LOT 6, FALCON MARKETPLACE

GRADING & EROSION CONTROL DOCUMENTS

GRADING & EROSION CONTROL PLANS FOR:
LOT 6, FALCON MARKETPLACE
EL PASO COUNTY, COLORADO

PPR2249

EL PASO COUNTY

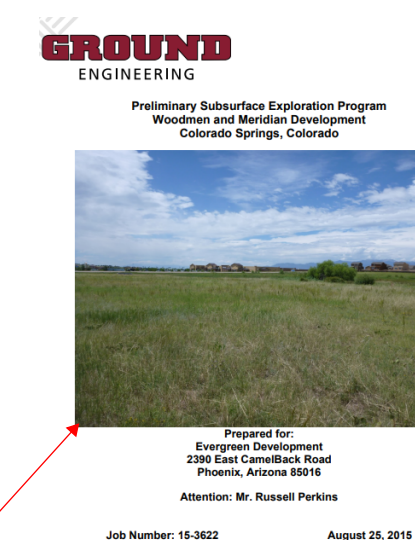
Remove "Interim"

Vehicle Tracking Control (VTC) SM-4

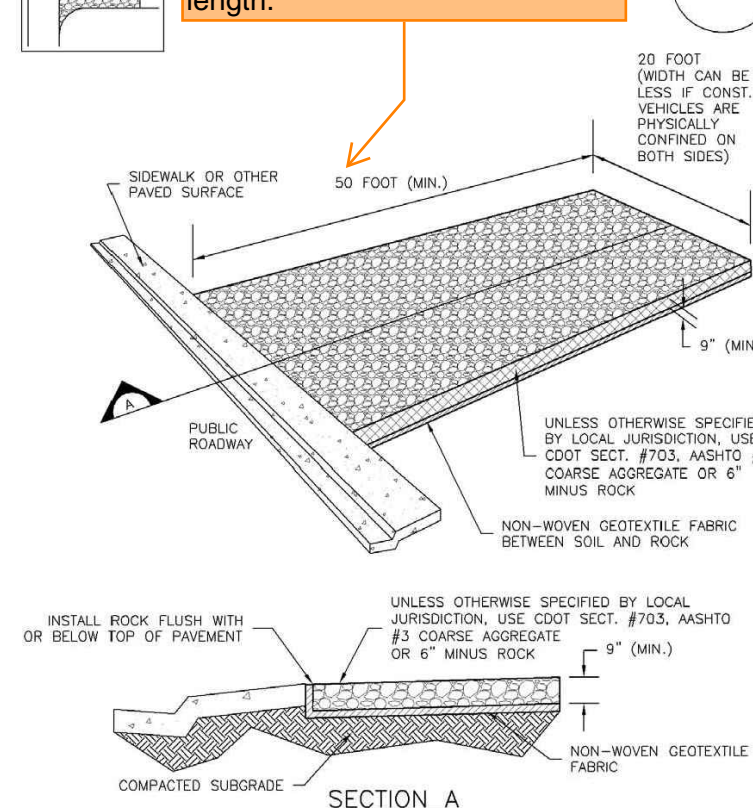
replace with EPC approved VTC detail (VT-1 and VT-2 in DCMV2, Chap 3.3) or revise to be 75ft min length.
